RE: Mesa Del Sol Montage Unit 3B
Revised Grading Plan Stamp Date: 6/6/19 (Sheets 1 & 5)
Grading Plan Stamp Date: 2/15/19
Drainage Report Stamp Date: 1/18/19
Hydrology File: R16D006

RE: Mesa Del Sol Montage Unit 3B
Grading Plan Stamp Date: 2/15/19
Drainage Report Stamp Date: 1/18/19
Hydrology File: R16D006

Re: Project No 775782: Mesa Del Sol, Montage Unit 3B - Re-Submittal
-Drainage Report for Mesa del Sol Residential Montage Unit 3 and 4 (Prior Stamp Date:
4/25/2014) New Stamp Date 01/18/2019
-Grading & Drainage Plan (Prior Stamp Date 8/29/2018) New Stamp Date 01/18/2019

MESA DEL SOL NEIGHBORHOOD MONTAGE UNITS 3 & 4 DEVELOPED CONDITIONS UPDATED BASIN MAP 10/2018

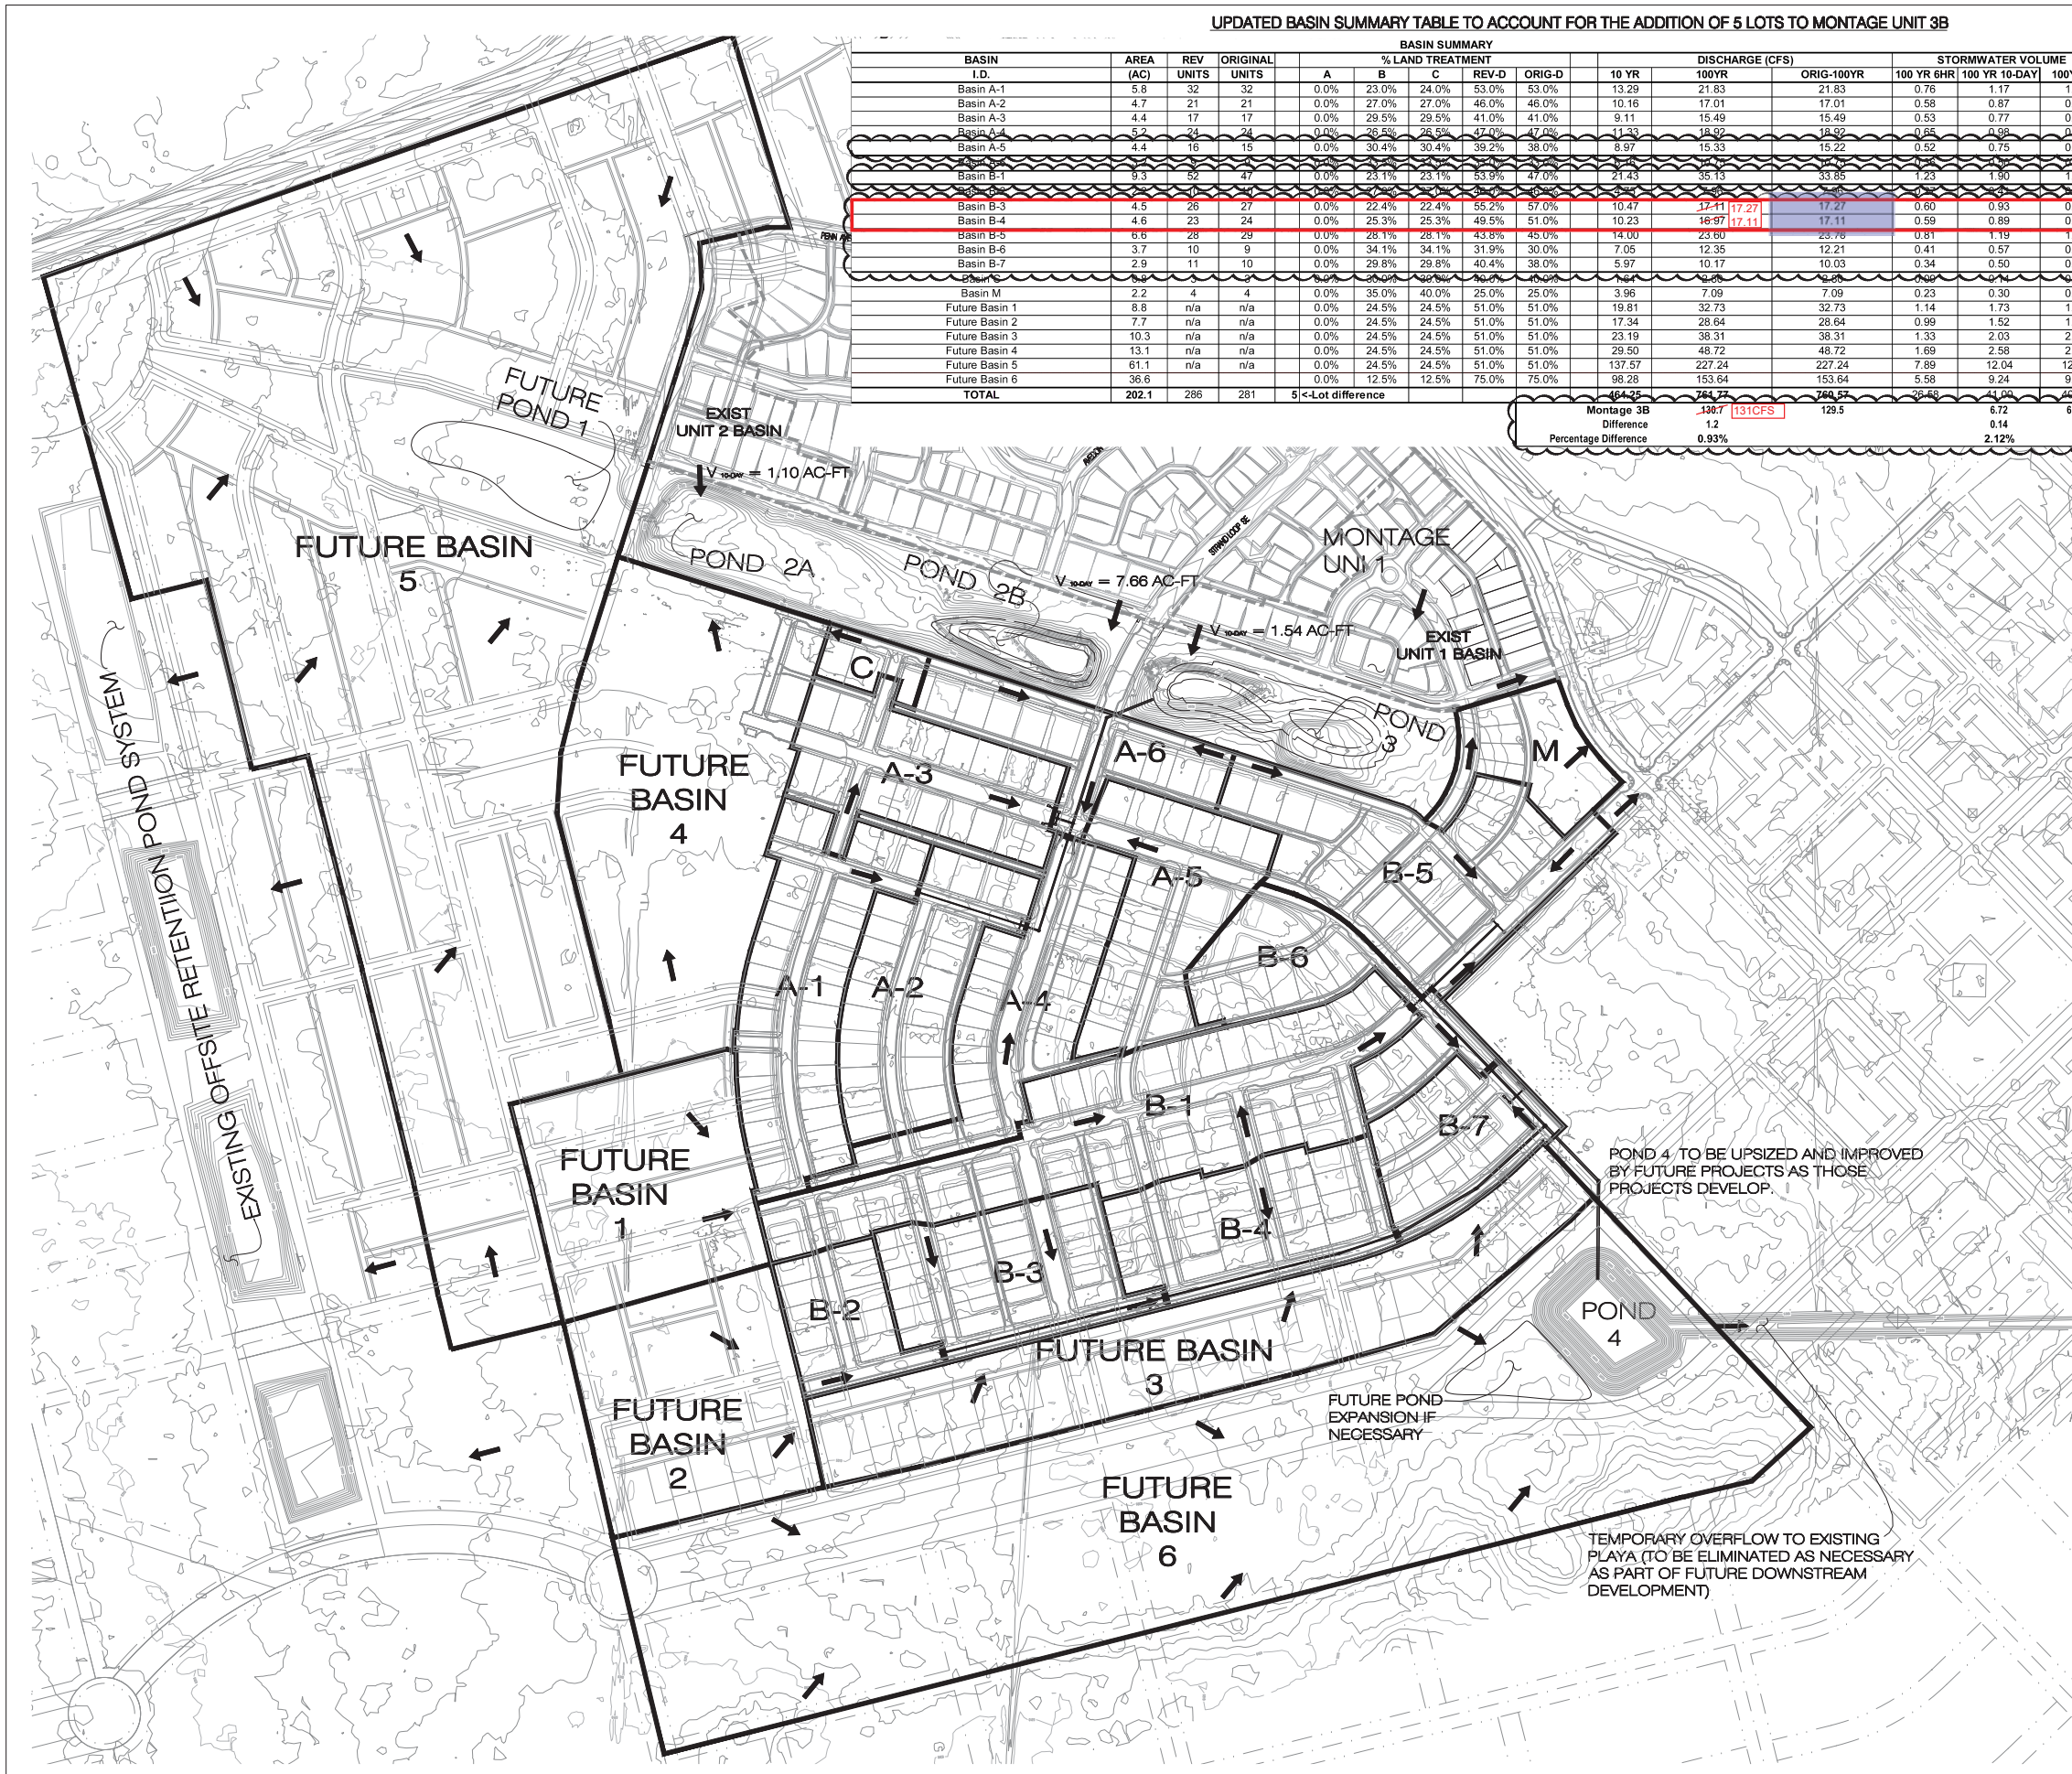
UPDATED BASIN SUMMARY TABLE TO ACCOUNT FOR THE ADDITION OF 5 LOTS TO MONTAGE UNIT 3B

3. The pond volume summary on the revised Basin Map is not adequate for review. Since this plan is revising the previous design of the ponds, a complete presentation of all related calculations is required. Detailed pond volume calculations are required including hydrology calculations and basin maps of all areas that drain to the ponds and volume calculations that show the area of each contour and the associated volume calculated using the conic equation. The Drainage Report for Mesa del Sol Residential Montage Unit 3 and 4 has been revised to address these comments. The existing volumes from Montage Units 1 and 2 entering the Ponds 2B and 3 is 7.75 ac-ft and was taken from the Approved Drainage Report Mesa del Sol Residential Montage Unit 1 and 2, revised 01/14/2011, COA Record Number R16D003A. The proposed development for Units 3 and 4 increases the pond volume requirements by 8.61 ac-ft. The total required pond volume is 16.36 ac-ft. The design capacity of the ponds is 19.71 ac ft. The ponds therefore have adequate capacity for existing and proposed conditions in their current design. Details of these calculations are discussed in Section V, Exhibits 5 and 6, and

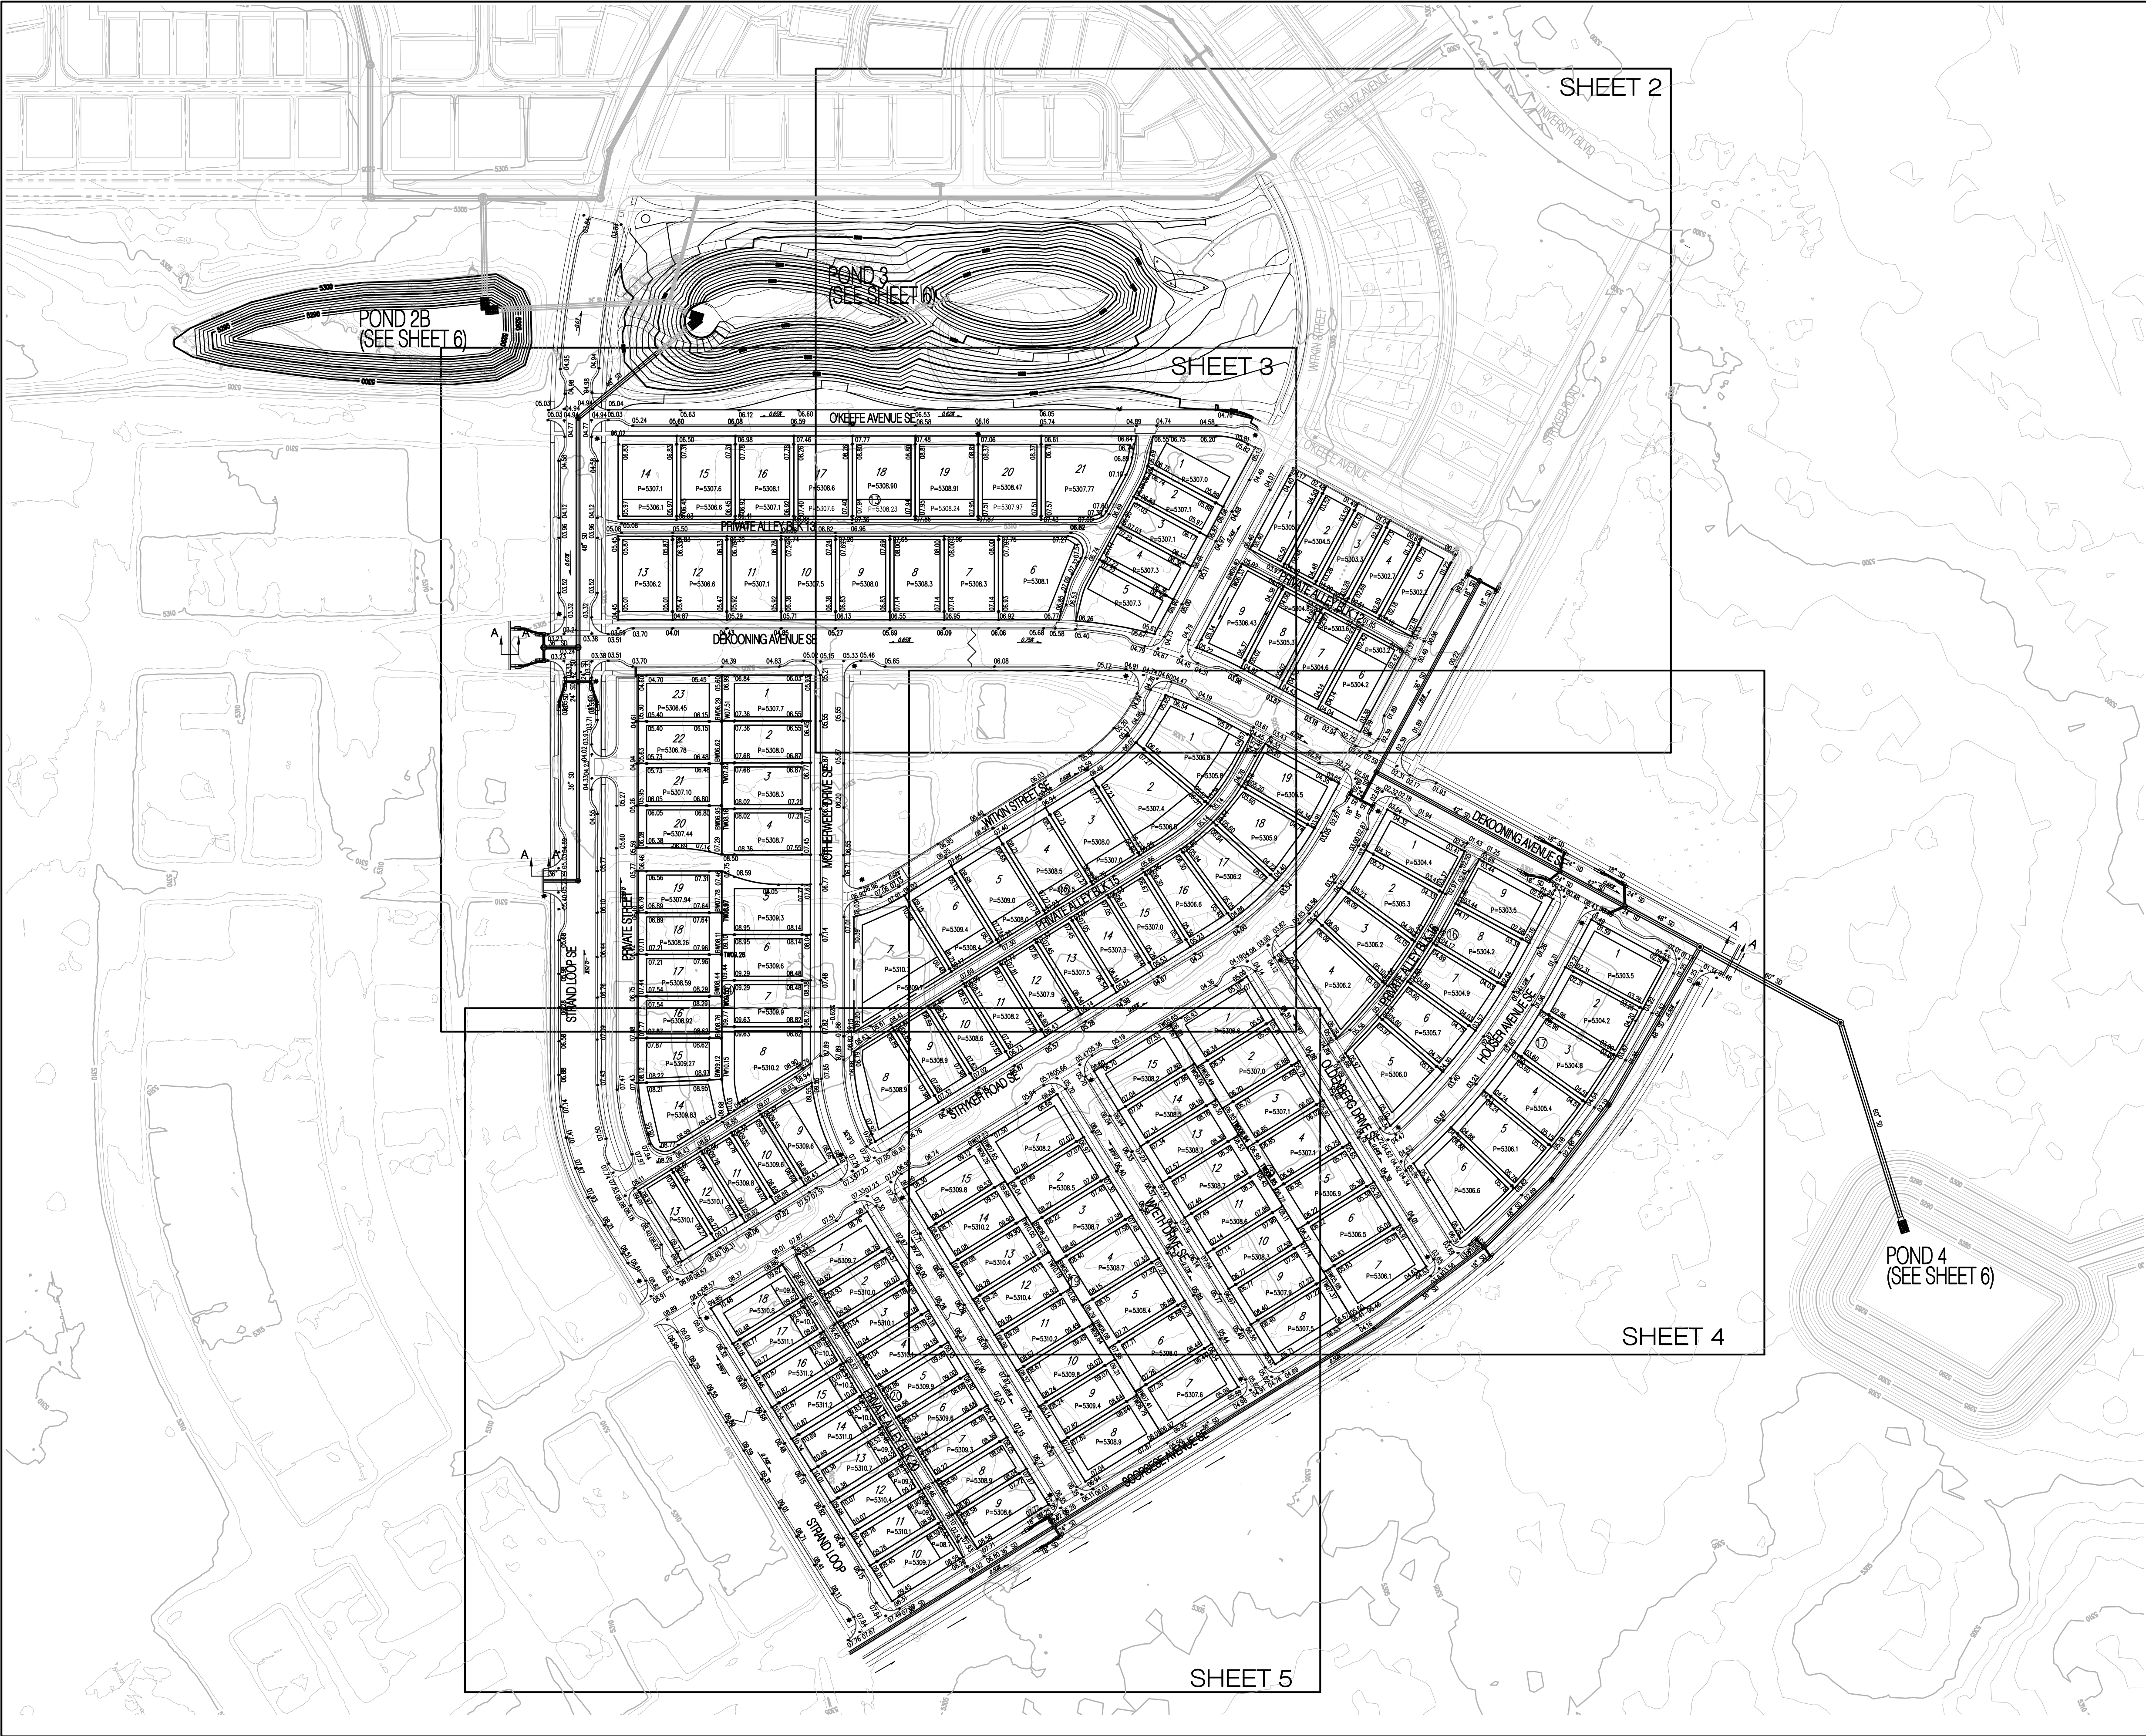
Show all pipes connecting to the ponds and provide HGL calculations for the pipes. Label 1 00-year water surface elevations and associated volumes of the ponds. Additional pond comments may be forthcoming after the design calculations are provided. The pipes are shown on the attached grading and drainage plan and updated on the Basin Maps within the drainage report. Per conversations with City Hydrology, HGL calculations have been checked in areas that have been considered critical and adjusted as necessary. In addition, the 100 year water surface elevations are also noted on the Developed Basin Maps within the Drainage Report.

4. Provide HGL calculations per DPM and profiles showing HGL. The In Roads calculations in the report do not account for the minor losses using the DPM equations. An overall plan view and profiles should be included with the hydrology submittal and must agree with the G&D Plan. Profiles of all pipes, including the laterals, are required both in the Hydrology submittal and on the DRC plans... Per conversations with City Hydrology, HGL calculations are not required to be shown on the re-submitted Grading and Drainage plan set. However, BHI reviewed the HGL calculations and have shown the pipe design to be within acceptable standards and adjusted on the plans as necessary. See Attached "Hydraulic Analysis for Storm Drain using StormCAD for HGL Calculations" for the critical storm drain system out falling into Pond 3.
